PRODUCT CHANGE NOTIFICATION

Bourns® Model SDE0302A, SDR0302 and PM32 Series SMD Power Inductors

Carrier Tape Thickness Change

IC23087

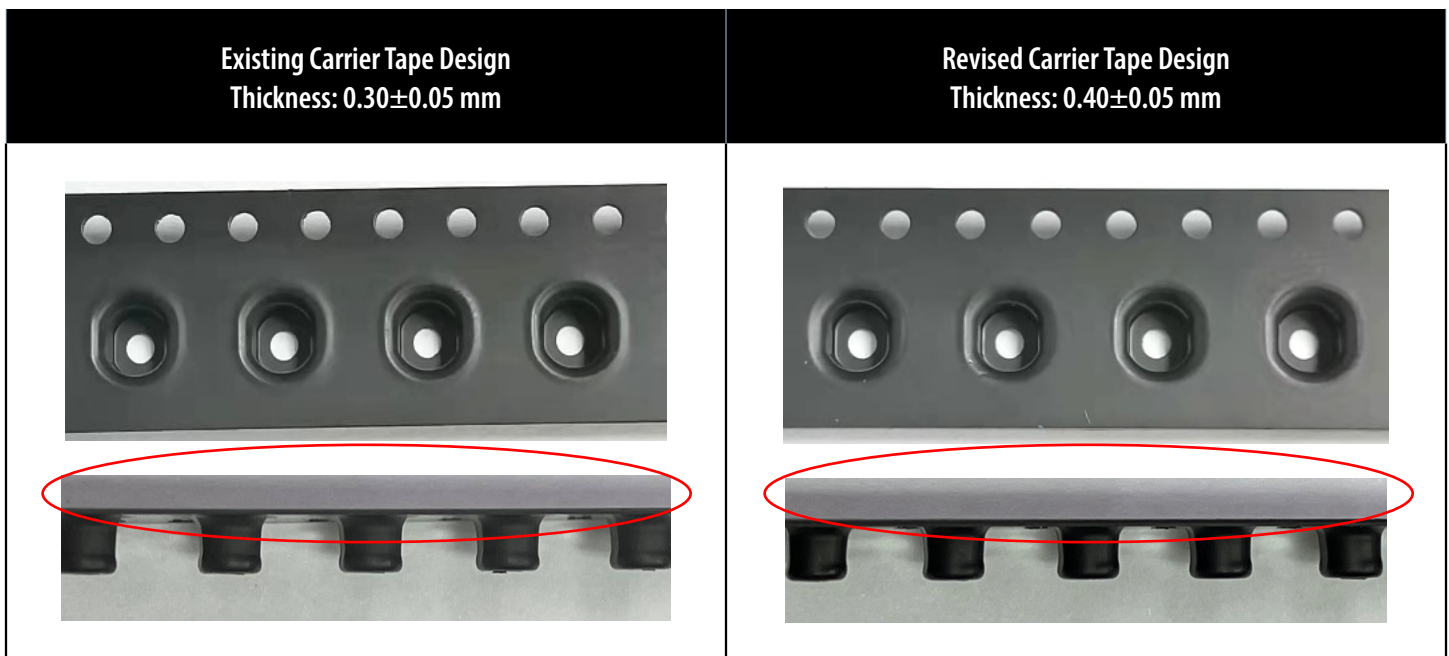
Riverside, California – September 18, 2023 – In the spirit of continuous improvement, effective January 22, 2024, Bourns will change the thickness of the carrier tape for the Model SDE0302A, [SDR0302](#) and [PM32](#) Series SMD Power Inductors. This design change will strengthen the structure of the tape pocket to better protect the contained component from damage during freight transit and handling. A list of affected part numbers is included below.

The form, fit and function of the inductors will not change as a result of this change to the carrier tape. The quality and reliability of the inductors should be improved with the change to the carrier tape. Traceability will be maintained through lot code and date code.

Date that manufacturing of existing carrier tape will cease: *January 22, 2024*

Date that deliveries of modified carrier tape will begin: *January 23, 2024*

First date code using the above changes: *2404*
